**Re: Heritage Marketplace  
Drainage Report and Grading and Drainage Plans  
Engineer's Stamp Date 3-25-15 (H09D024)**

HERITAGE MARKET PLACE  
ALBUQUERQUE, NM

RE: HERITAGE MARKET PLACE (H09D024)

# **DRAINAGE REPORT**

**GR-1**

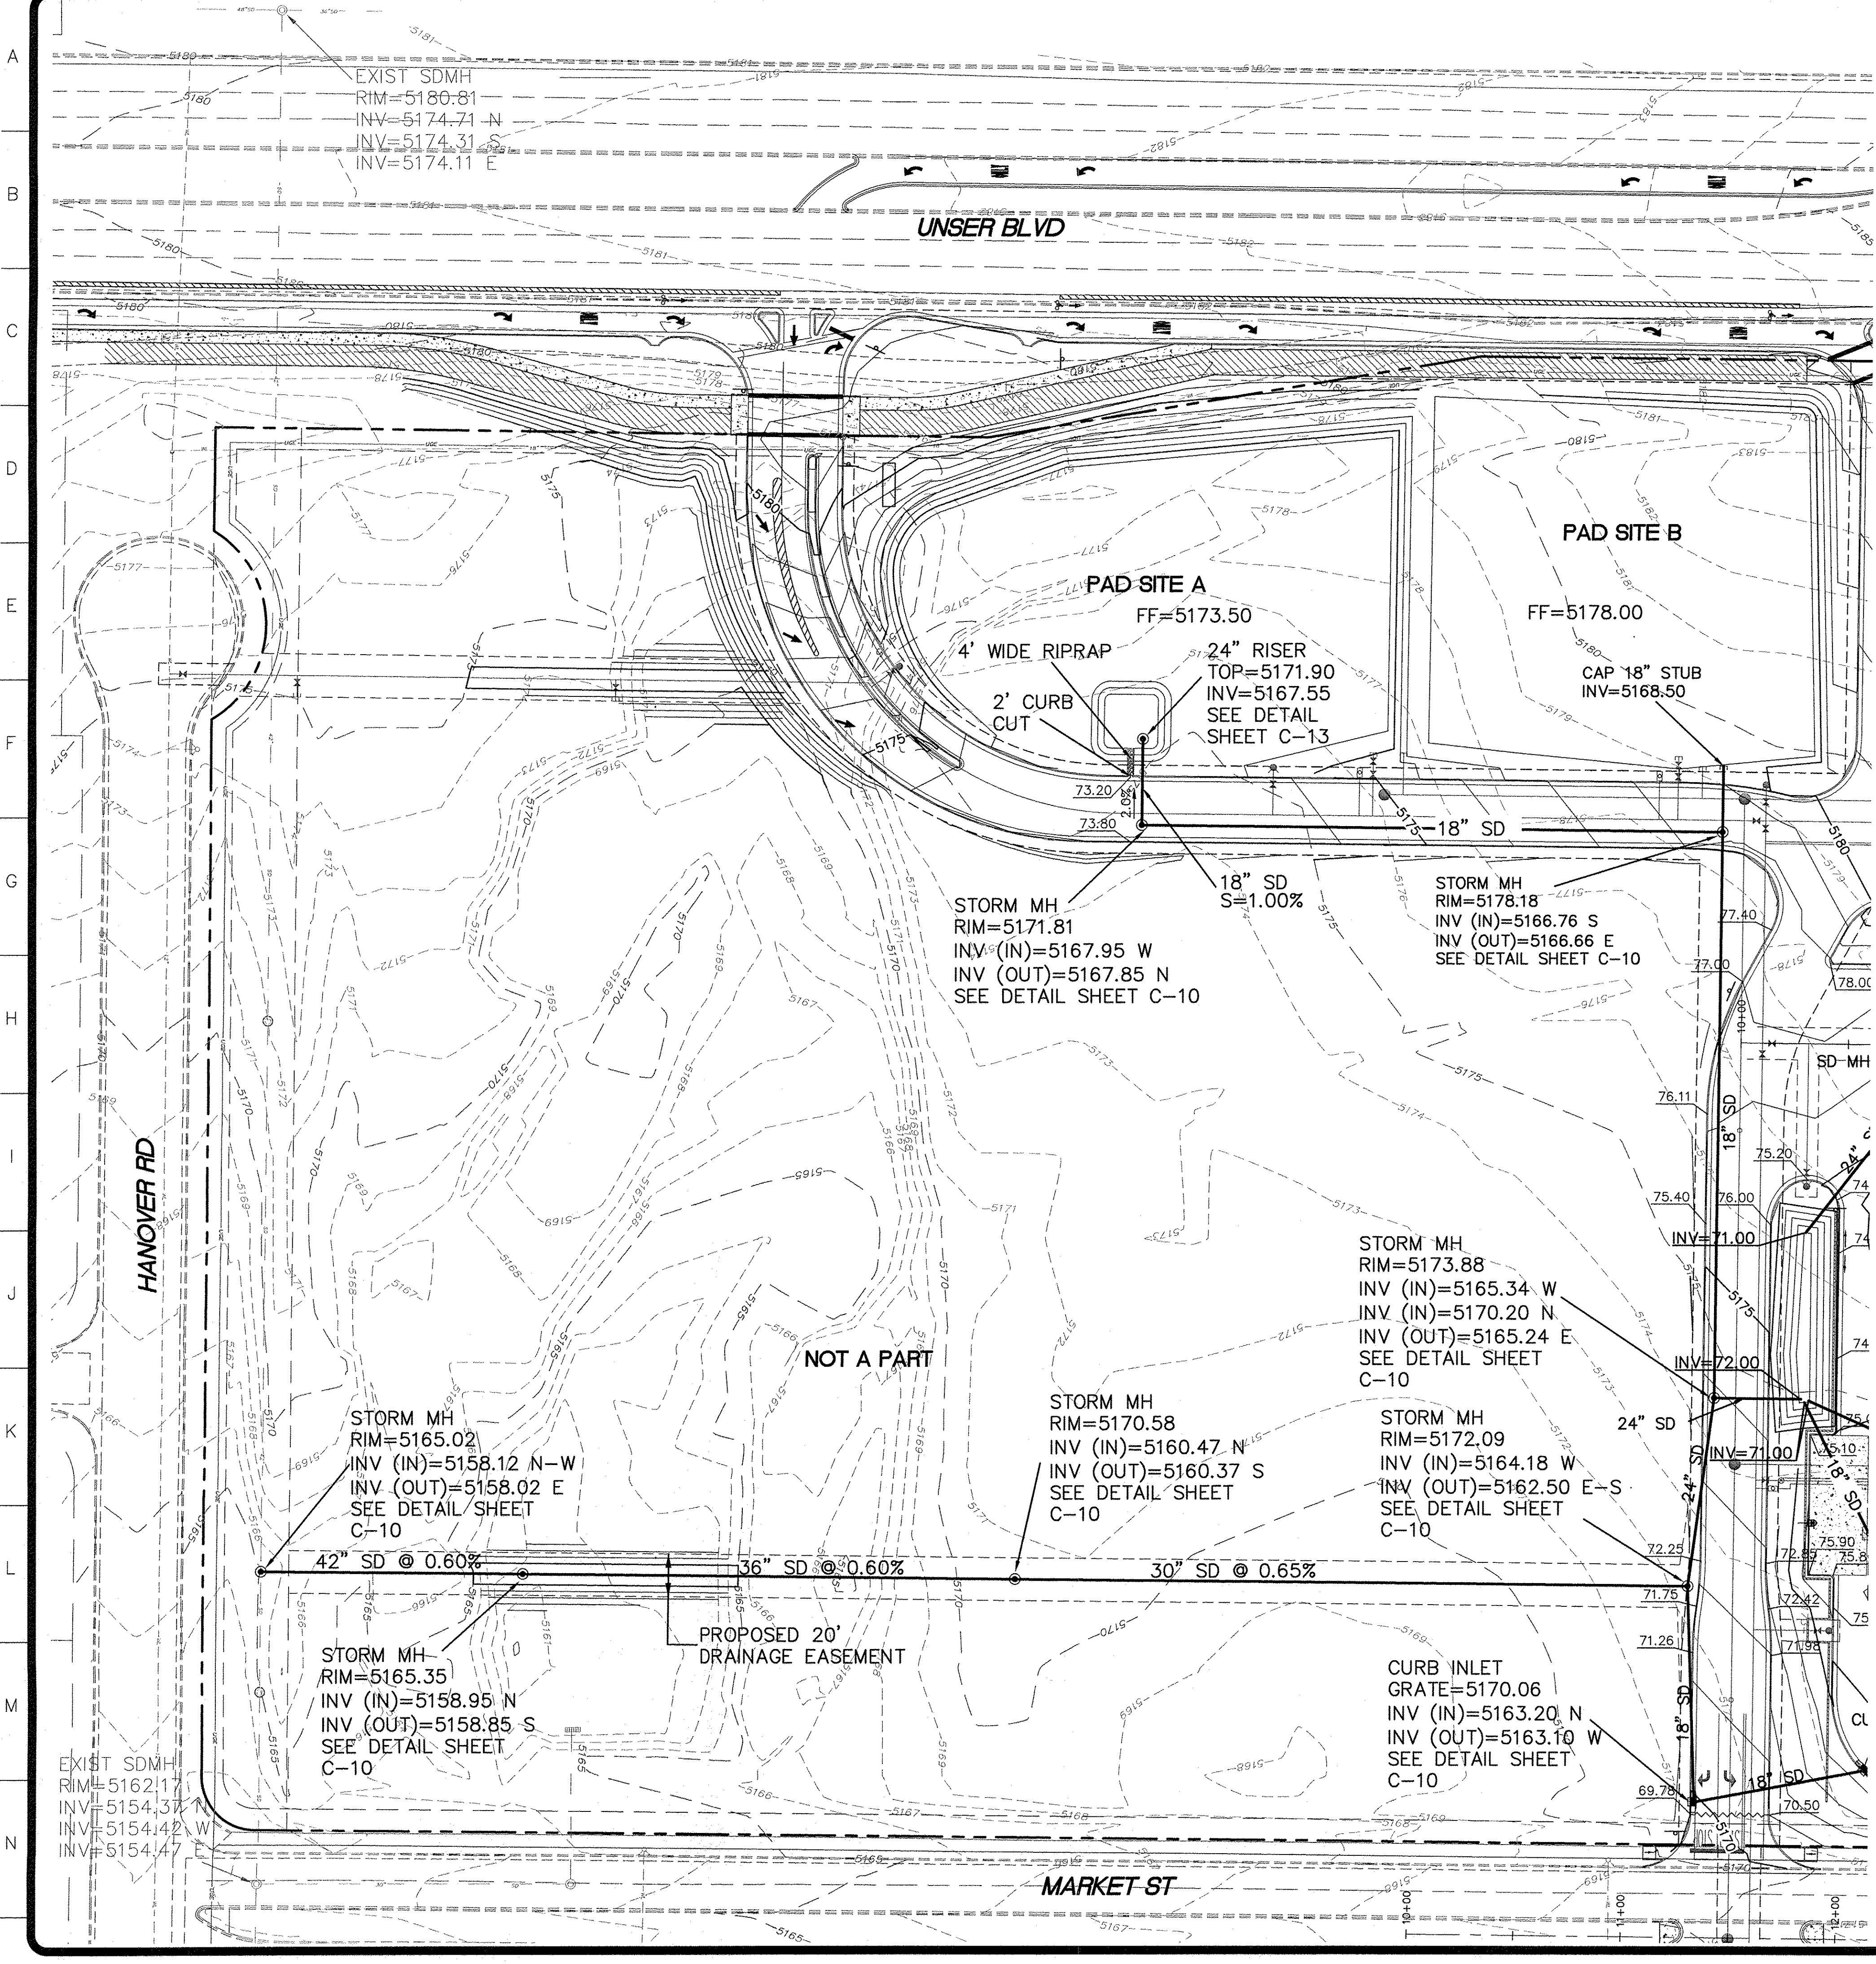
1. It appears the sump near Pad Site A and the pad grade of Pad Site A is lowering the storm drain profile and making it difficult to drain Basin B3 into Pond 2 to capture the first flush. If the road was straight-graded and Pad Site A raised, this would create enough grade to raise the storm drain profile and drain Basin B3 into Pond 2.

4. The narrative for pad site C is for a different location.

**Response: The grading design was revised to incorporate a water quality basin within Pad Site A to account for Basin B3. We analyzed "straight-grading" the roadway, however, the elevations necessary at the driveway between Pad B and C made this option impractical.**

**Response: An updated grading plan is attached for review with narrative removed (analysis covered by drainage report).**

| SHEET   | C-6     |

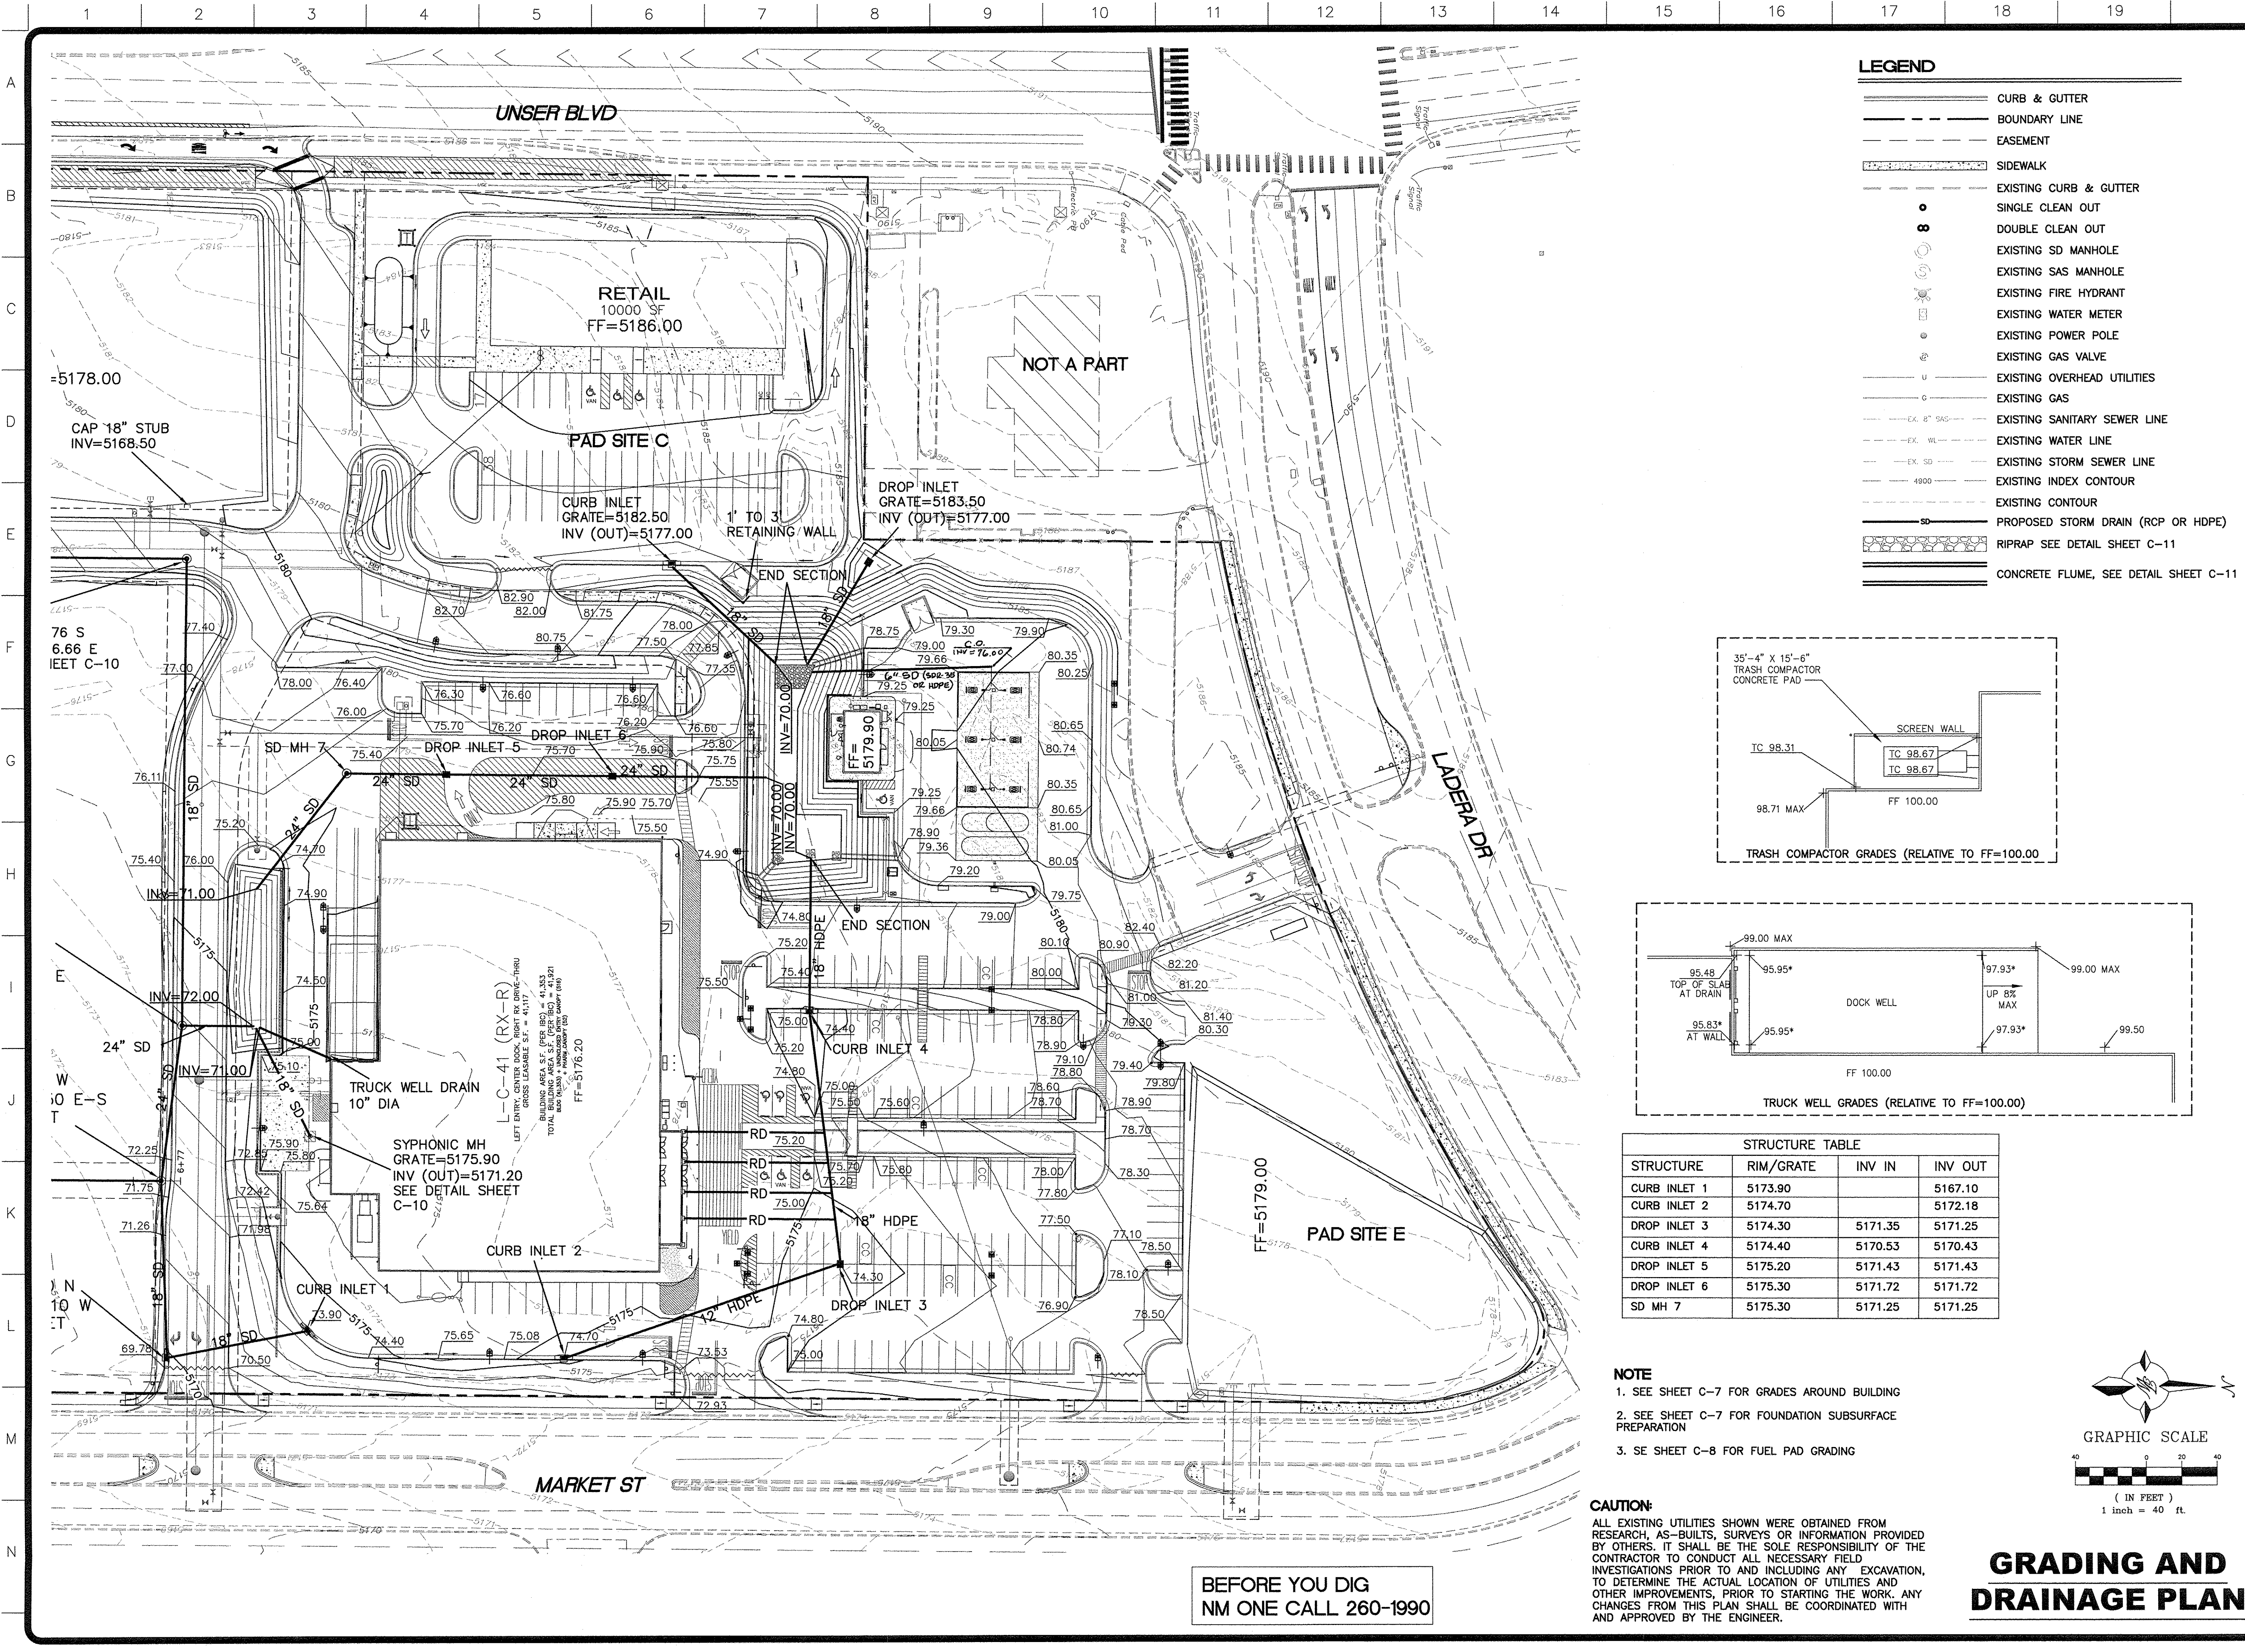
2. The first flush runoff from the roof of the anchor store should be retained. The finished floor elevation is 76.2 and the pond bottom is at 71 (70 in first flush calcs), so it appears easy to capture this stormwater.

**Response: The roof drain connection was revised to connect to the pond behind the store, as requested.**
